UNITED STATES PATENT AND TRADEMARK OFFICE

10/826,684

Office Action Summary	Application No. 10/826,684	Applicant(s) MALANDAIN, HUGUES F.	
	Examiner MICHAEL J. ARAJ	Art Unit 3733

Figure 1 (taken from '166)

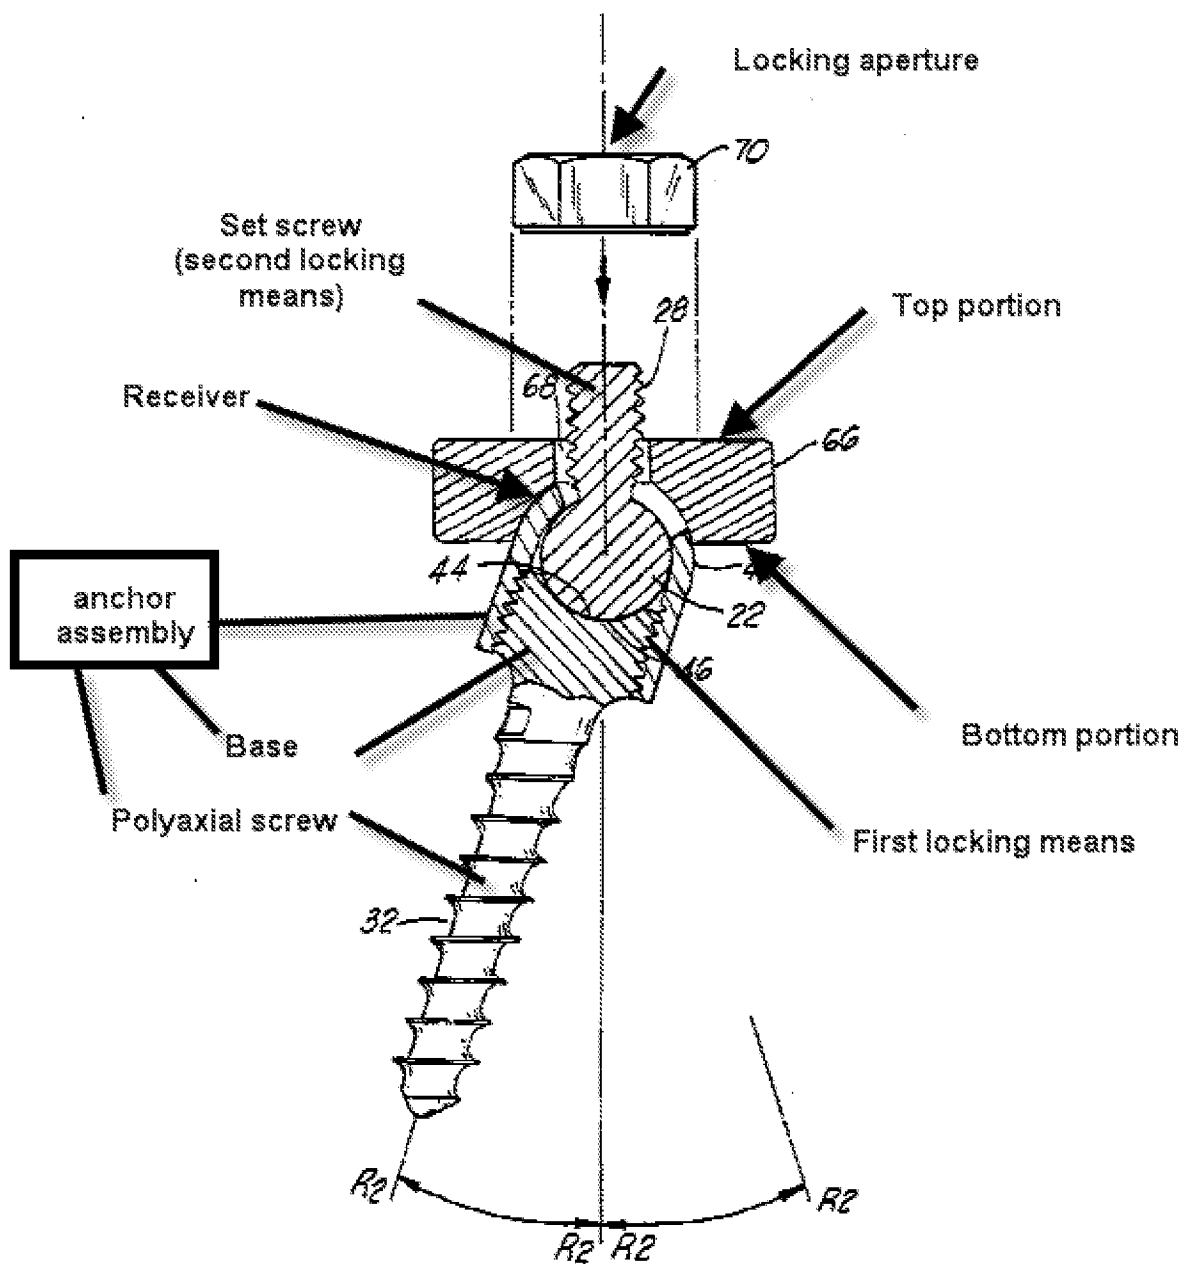
Bernhardt et al. disclose an elongate plate support element with a top portion and a bottom portion having a bottom surface and on or more apertures passing therethrough that spans two or more vertebrae (Fig. 1). The bottom surface includes a receiver configured to receive a plurality of anchor assemblies wherein the anchor assemblies includes a means for locking the anchor assembly to the bottom portion of the support element. The means for locking includes a locking aperture. When

assembled, the anchor assemblies do not pass through the support element. (**See Figure 1 below**) The base is comprised of a base head wherein the base head is movably disposed within the anchor assembly. The base head is consisting of a polyaxial connector and can be locked in a desired position. One or more apertures have dimensional configuration providing access to the base and the means for locking the base to the anchor assembly through the top portion of the support element, wherein the head of the base for the anchor assembly does not pass through the support element. The apertures (14), as seen in Fig. 1 of '166, provide this access. The anchor assembly can have a 90-degree twist on configuration depending on its application. The receiver is integrally disposed and attached within the bottom surface of the bottom portion of the support element having a configuration of a slot. The receiver or access ports spans the length of the bottom surface and is comprised of two closed ends. The means for locking the anchor assembly to the support element includes a setscrew (28) disposed within the locker aperture of the nut (70), wherein the screw and locker aperture are threaded.

Bernhardt et al. also disclose a methods of implanting a plurality of anchor assemblies having bases into the bone with a first and second locking means (see Figure 1 above), connectively positioning a support element with a receiver, locking the bases within the anchor assemblies and locking the anchor assemblies within the support element receiver, where the anchor assemblies do not pass through the support element. The support element is disposed within a body location such as subcutaneous fat layer of the spine. It also can be viewed that the support element is disposed external to the body when the surgery is taking place.
